City of Tukwila

# Draft Southcenter Design Manual

CITY COUNCIL REVIEW DRAFT

Planning Commission Recommended Draft with Staff Updates  
in Strikeout/Underline

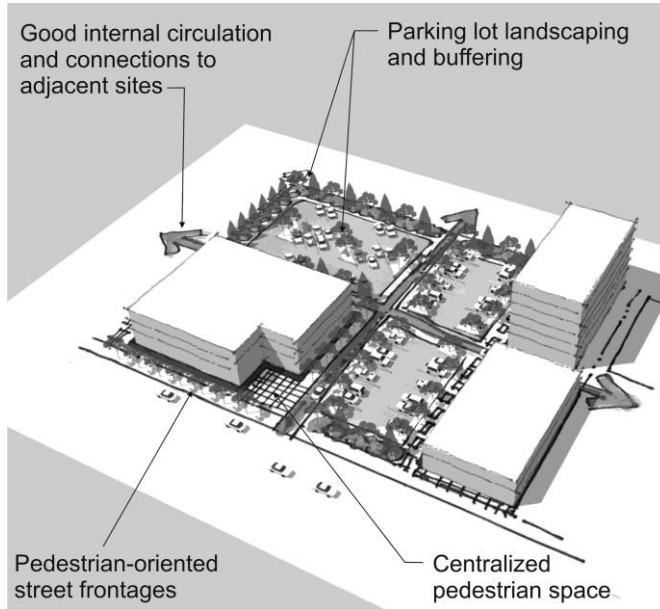
**Comment [MK5]:** Updated figure

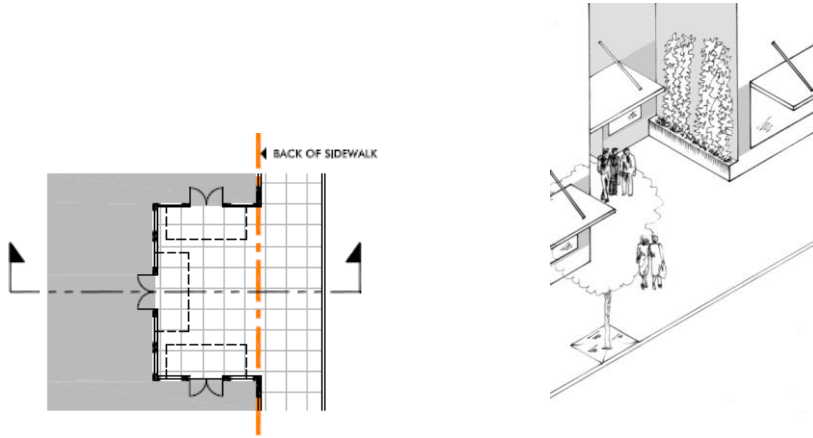
**Comment [MK21]:** Replaced text describing forecourt concept with better graphics

### Stoop examples.

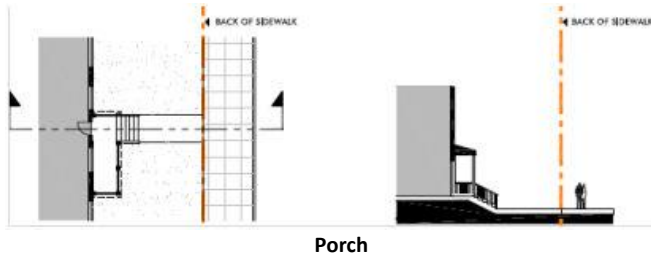
**Comment [MK25]:** Replaced original figures with graphics that better illustrate concepts

### 16-10. BUILDING **MODULATION****MASSING**

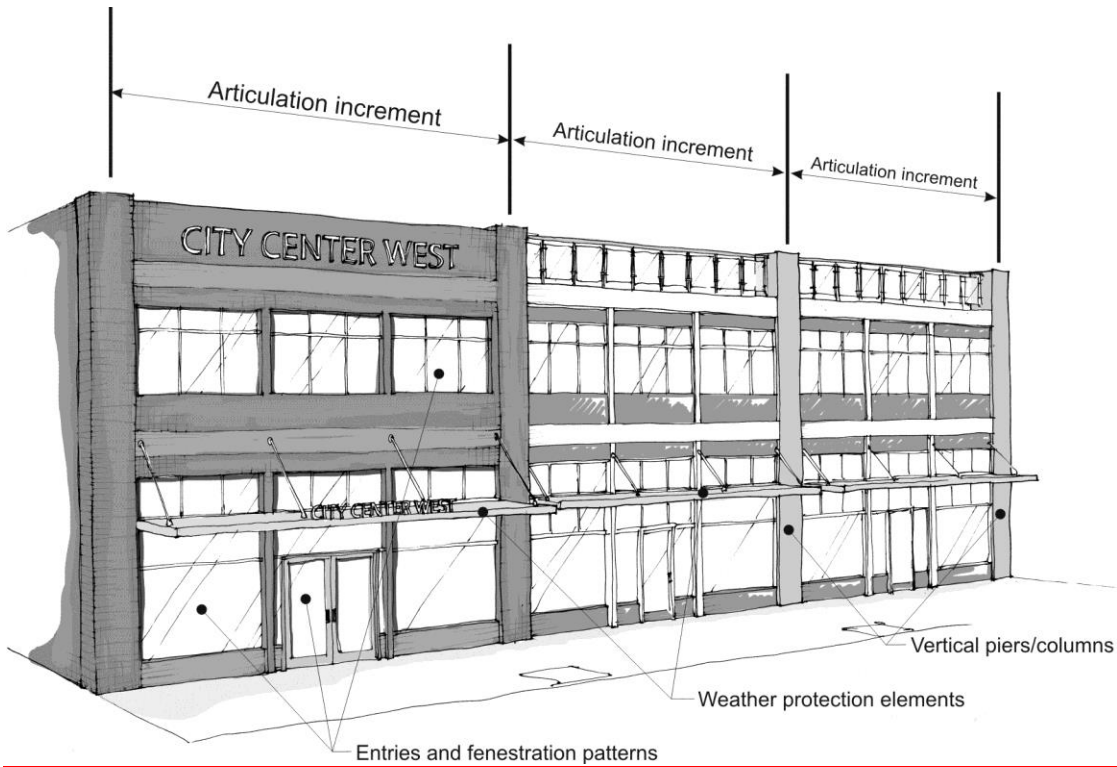
**Comment [MK39]:** Relocated from above. This replaces the original section on Building Modulation; now is consistent with revisions regarding Architectural Design standards in TMC
